HISTORIC AND DESIGN REVIEW COMMISSION

August 18, 2021

HDRC CASE NO: 2021-396
ADDRESS: 317 WICKES
LEGAL DESCRIPTION: NCB 939 BLK 2 LOT 5
ZONING: RM-4, H
CITY COUNCIL DIST.: 1
DISTRICT: King William Historic District
APPLICANT: Roger Williamson/WILLIAMSON FAMILY PROTECTION TRUST
OWNER: Roger Williamson/WILLIAMSON FAMILY PROTECTION TRUST
TYPE OF WORK: Porch step and handrail modifications
APPLICATION RECEIVED: July 10, 2021
60-DAY REVIEW: Not applicable due to City Council Emergency Orders
CASE MANAGER: Rachel Rettaliata

The applicant is requesting a Certificate of Appropriateness for approval to:

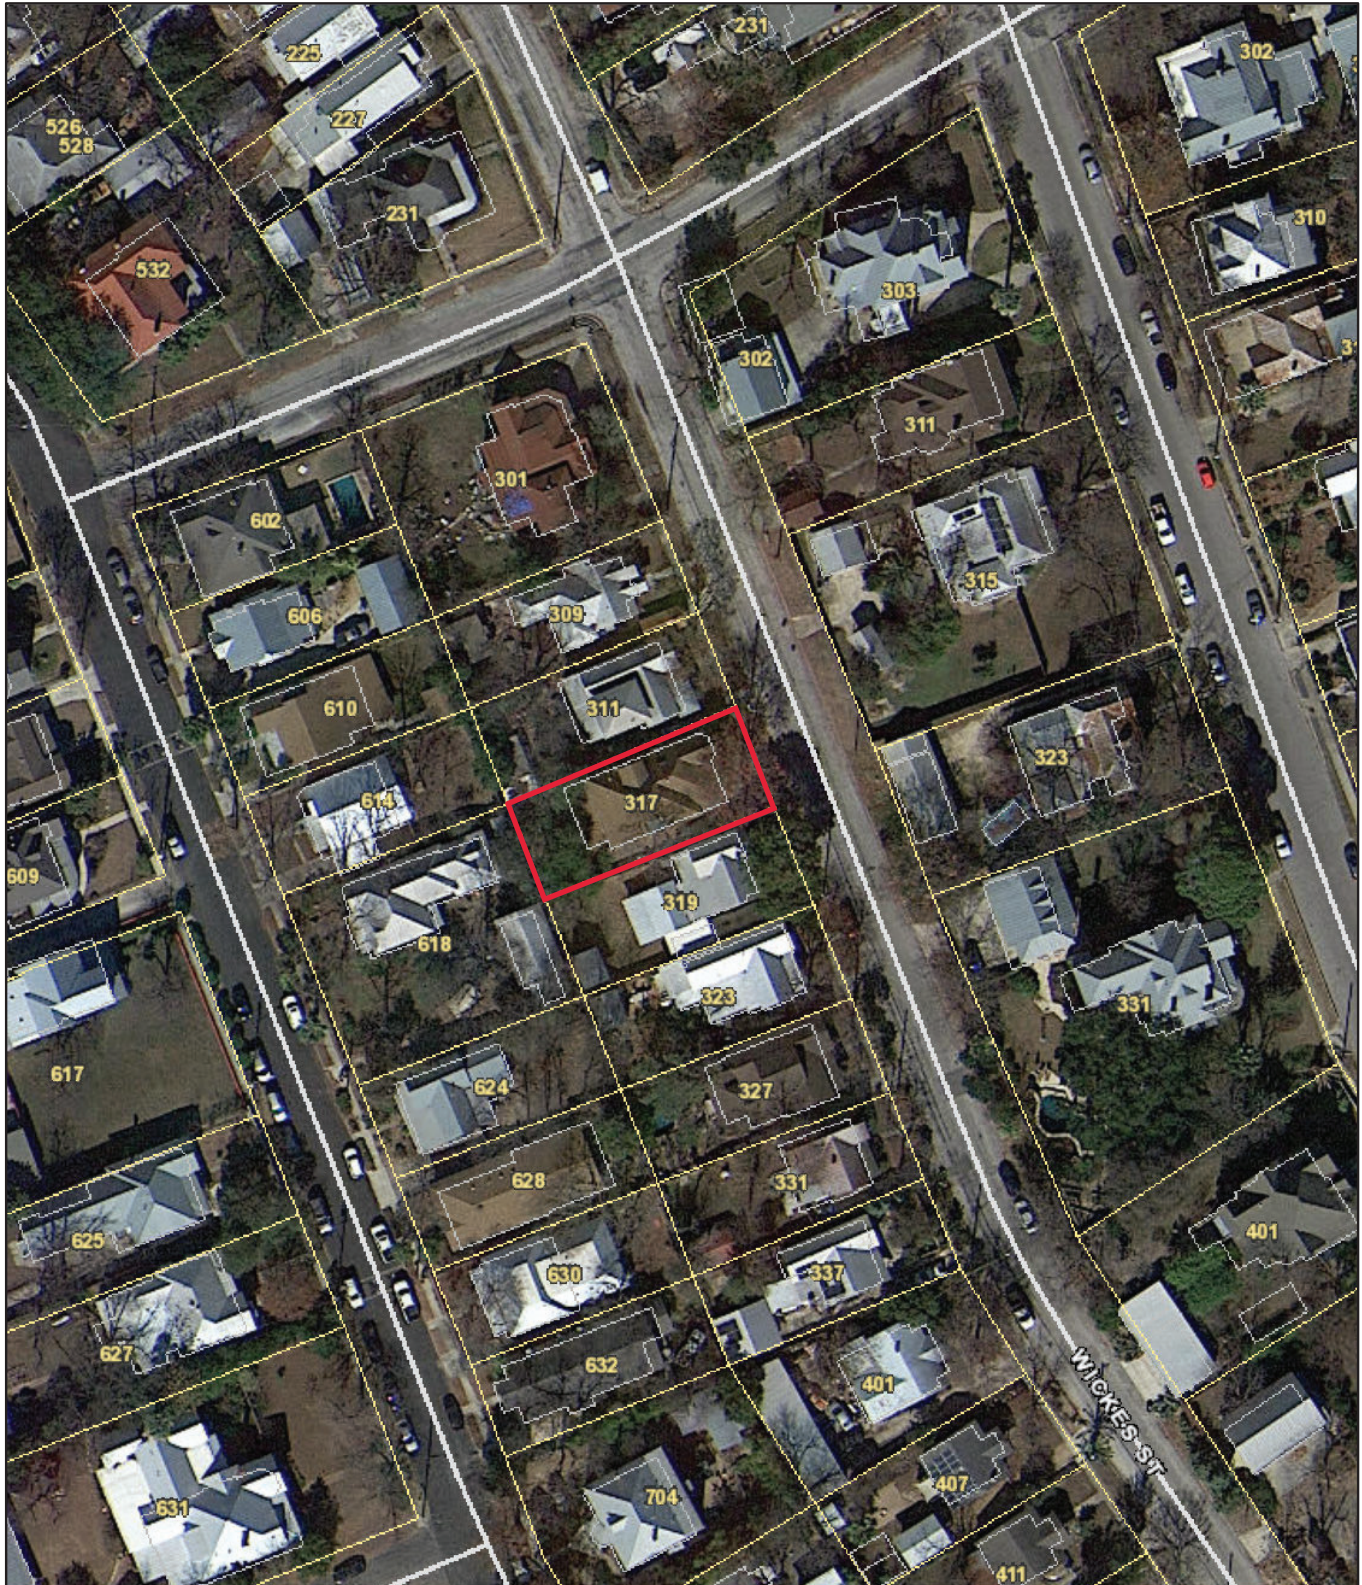
floors of wood or concrete with carpet, tile, or other materials unless they were used historically. Additionally, Guideline 7.B.iv for Exterior Maintenance and Alterations states that replacement elements, such as stairs, should be designed to be simple so as to not distract from the historic character of the building. Do not add new elements and details that create a false historic appearance. As the front porch features wood decking and the concrete front porch steps are likely not original to the structure and the requested wood step overlay is reversible, staff finds the request generally consistent with the Guidelines. Staff finds that the applicant should take steps to control the collection of moisture and vegetation between the concrete steps and the wood step overlay to prevent deterioration.

- c. **HANDRAIL INSTALLATION** – The applicant has proposed to install a wood handrail at the front walkway steps. The example handrail submitted with the application materials is not appropriate for installation. Staff finds that the wood handrail installed at the front walkway steps should match the handrail proposed for installation at the front porch steps.

- i. That the applicant installs fully wood railings at the front porch and front walkway steps that feature both a top and bottom rail. The bottom rail should feature a vertical orientation and should be installed approximately three to four inches above the steps. Both top and bottom rails should be constructed from 2"x4" members. The proposed railing should not feature an overall height of more than three (3) feet.
- ii. That the applicant submits updated material specifications for the proposed front porch step and front walkway step railings to staff for review and approval prior to the issuance of a Certificate of Appropriateness.
